STAFF REPORT 07-02-2025 SPECIALMEETING PREPARED BY: A. BUSH, G. LANDSBERG

APPLICATION NUMBER: HDC2025-00243

APPLICANT: DETROIT THERMAL

SCOPE: EXCAVATE FOR EXISTING STEAM PIPE SLIPLINING AND NEW STEAM PIPE INSTALLATION, INSTALL CONSTRUCTION FENCING/TREE PROTECTION, RESTORE CONCRETE CURBS/LANDSCAPE/PAVEMENT (WORK STARTED WITHOUT APPROVAL)

- 1 – Antietam Vicinity

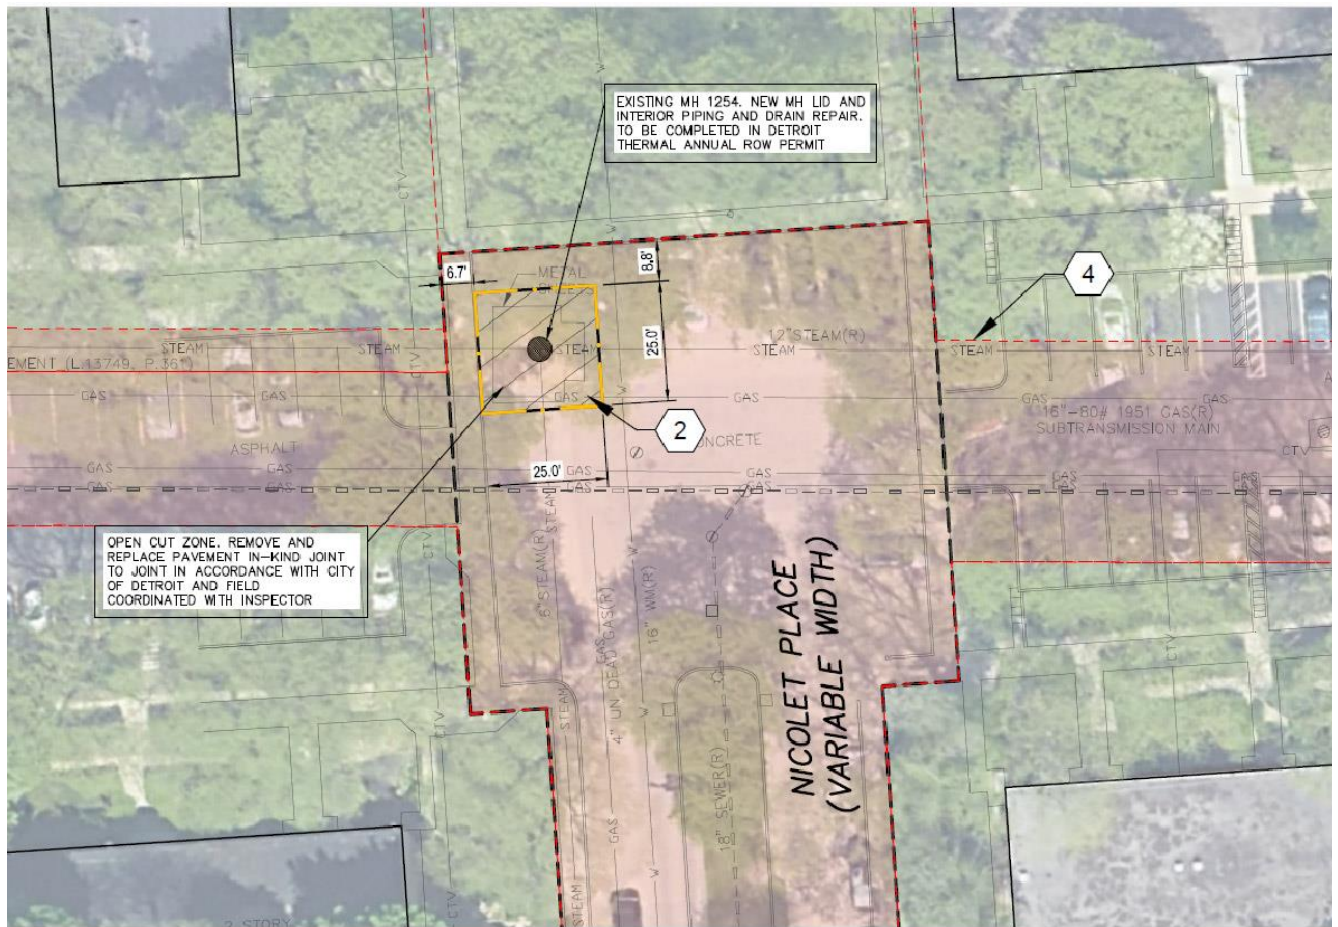
IDENTIFICATION OF KEY FEATURES: The location of work around the existing MH 1255 is located in the Antietam St right of way in the Pavilion Character Area. While Antietam plays a role in the spatial organization of the project by defining the edges of the superblock and vehicular circulation at its perimeter, the materiality of the streets change over time as the city maintains this as an active public road and it appears to be paved following conventional methods and materials. Overall, it has a medium level of historic sensitivity. The red line shown in the center line of Antietam is the boundary of the historic district, with the district being toward the top and right side of that line in this drawing.

PROPOSED REHABILITATION: The applicant proposes a 15' by 15' open cut into the right of way to install new interior piping and a new manhole lid, and replacement of the pavement in-kind joint to joint once the construction is complete.

POTENTIAL IMPACTS TO HISTORIC RESOURCES: The open cut into the asphalt and replacement in kind do not jeopardize the spatial organization of this site feature. This work also does not appear to change the integrity of the road materials, which do not have a high degree of historic integrity from the period of significance given their ongoing standard city maintenance. This work does not appear to impact any adjacent vegetation, topography, circulation, structures, views, nor site features, and given its location, construction activities appear to be able to be accomplished from the paved areas of the street.

Circulation: Repair, applicant proposes to repair asphalt surfacing in kind

Structures, Furnishings and Objects: None, project replaces a manhole lid which is not a major character defining object

- 3 EAST – Lafayette Plaisance Vicinity

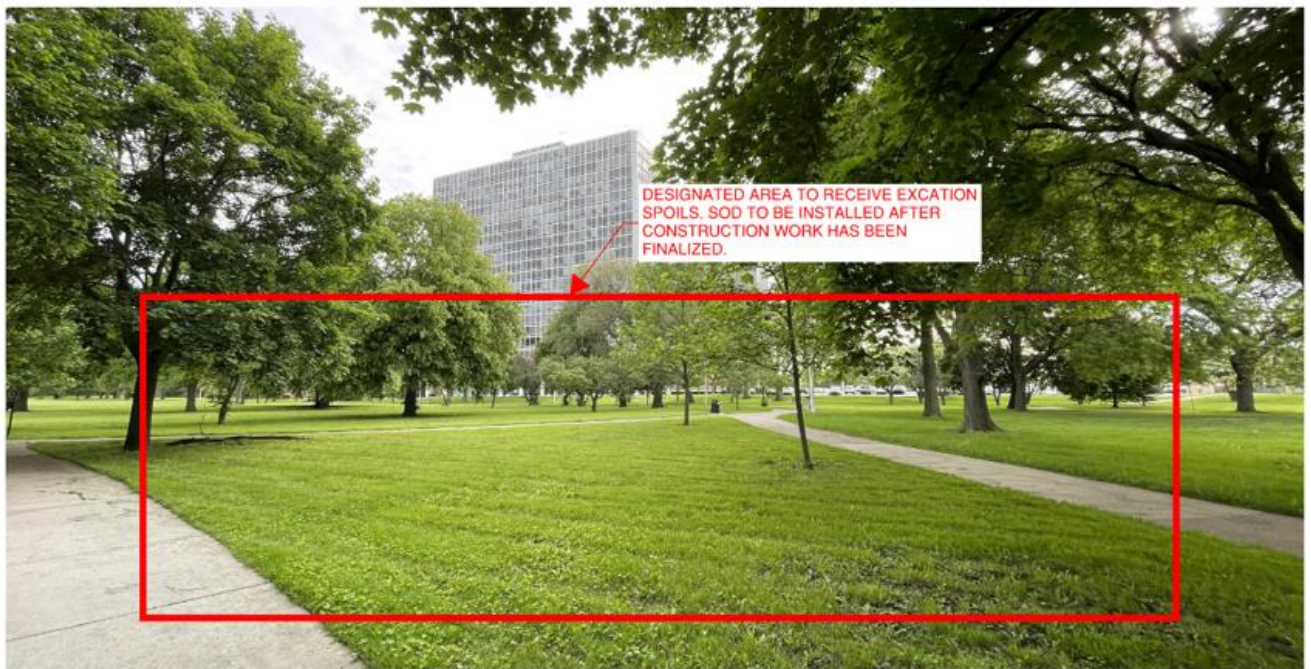
IDENTIFICATION OF KEY FEATURES (Structures, Furnishings, Objects): In this zone, the edge between the Plaisance and the Townhomes use both vegetation and the Townhomes to create an edge between the park and residential area, and together, buildings and landscapes shape the smaller outdoor rooms of the Townhomes area. This relationship between landscape and building architecture to define outdoor spaces remains intact and exhibits a high degree of historic integrity and significance. Between the

Plaisance and the Townhomes, the decorative fence between the townhomes (shown in brown above) does not appear in early plans for Lafayette Park and does not exist uniformly as a feature between all of the Townhomes and the Plaisance. It was likely added by residents after the project was built, not contributing to the historic significance of the district which emphasized pedestrian connectivity across the district. It is unknown if this fence was permitted or if it was installed before or after the designation of the local historic district.

PROPOSED REHABILITATION: The applicant's proposed scope for this area is to use the zone outlined in blue and labeled "1" below, as a location for staging for equipment and excavation spoils, and the purple path, labeled "2" below, as a route to reach the excavation site in the "Old Macomb Vicinity" from E Lafayette St. Outside of this area, construction access will occur to the south using the existing concrete walkway in the park. The applicant also proposes to remove and replace the decorative fence to get access through the easement to the "Old Macomb Vicinity." There is no excavation proposed in this area.

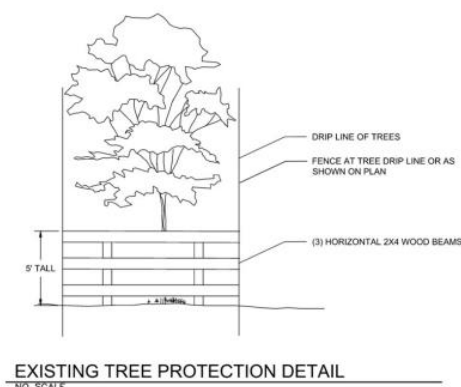
Proposed path for construction access to work site at "Old Macomb Vicinity" shown in purple, Plant 3 Spruce tree shown on lower right, as well as condition ground plane with exposed soils, from applicant documents (not to scale). Path tries to create the most direct and short connection, avoiding mature vegetation as much as possible, and remaining within the easement area in the Townhomes property.

Plant 3, the blue spruce is proposed to be trimmed in consultation with the project's arborist to accommodate access for construction equipment to the site so it will not have branches broken or torn by equipment using the path. In the Plant Index Chart, the post construction notes for tree care describe *“deep root fertilization and cultivation per arborist.”*

The applicant proposes to trim the spruce tree labeled as Plant 3 to protect it from having branches torn or broken by construction equipment. Given some of its sparse branching, limbing up the tree might further compromise its health, but could also jeopardize the naturalistic form of the tree, with horizontal branching that is a feature of the Prairie style. Tying back limbs if they are smaller than 3" diameter per the NPS recommendations could be explored. Replacement of this tree could provide a more consistent historic aesthetic depending on how much trimming is needed as this could impact the integrity of the spruce's form, its natural branching habit, which is currently branched to ground.

- Pulls and ties back limbs that may impede the construction zones rather than removes limbs of mature branches on Plant 3, spruce.
- Ensures hydroseed grass species matches existing turf grass in all areas of disturbance

4 – Joliet Place vicinity

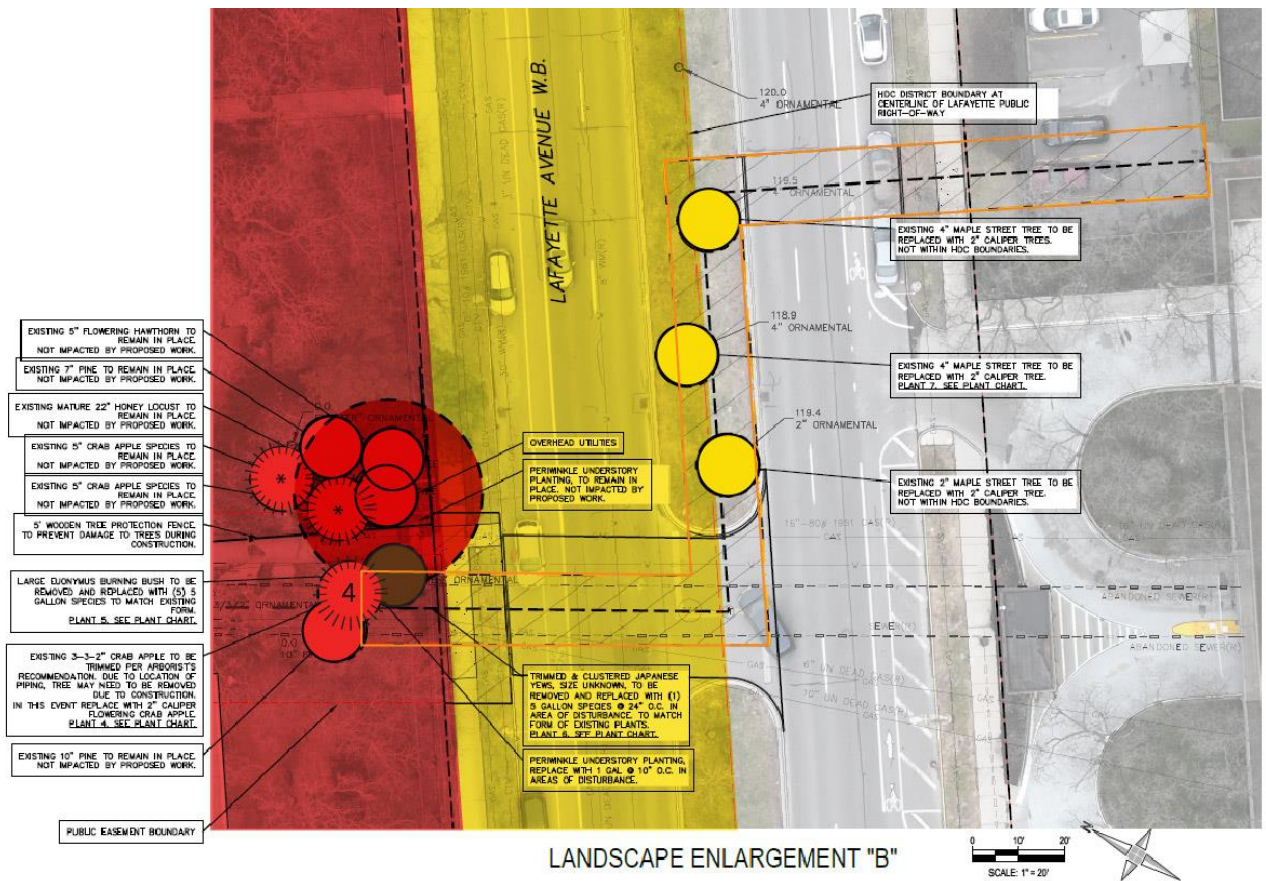
PROPOSED REHABILITATION: The proposed work has changed from the prior submission. Instead of one, the applicant now proposes to create two open excavation areas, one, 15' by 25' open cut area to slipline the existing steam pipe to the north to minimize impacts on the more sensitive landscape features, and a second, 15' by 23' open cut area toward the south, which will also support sliplining an existing pipe and replacement of an existing manhole lid. Both areas are proposed to be open cut in the concrete, with the paving replaced in kind, joint to joint post construction. It appears that construction work in these areas will take place on the hardscape and will not impact adjacent vegetation. The applicant no longer proposes any vertical vent stacks in this area as part of their rehabilitation project. This change would minimize the impacts on the views in the historic landscape. The proposed manholes do not vent steam.

POTENTIAL IMPACTS TO HISTORIC RESOURCES: From a construction access standpoint, it appears that the cut areas can be reasonably accessed and staged from paved areas in the cul-de-sac without impacting any adjacent vegetation. The subsurface work appears to have limited visual impact beyond the new manhole lid, as the proposed work is primarily subsurface. This subsurface rehabilitation and the replacement of concrete in kind does not impact the spatial organization of this feature, nor its topography, circulation, vegetation, nor the views from the Townhomes. There does not appear to be an impact to vegetation nor buildings in the surrounding vicinity.

Circulation: Repair, applicant proposes to repair pavement in kind

Structures, Furnishings and Objects: None, project replaces a manhole lid which is not a major character defining object and complete other subsurface utility work which is not visible
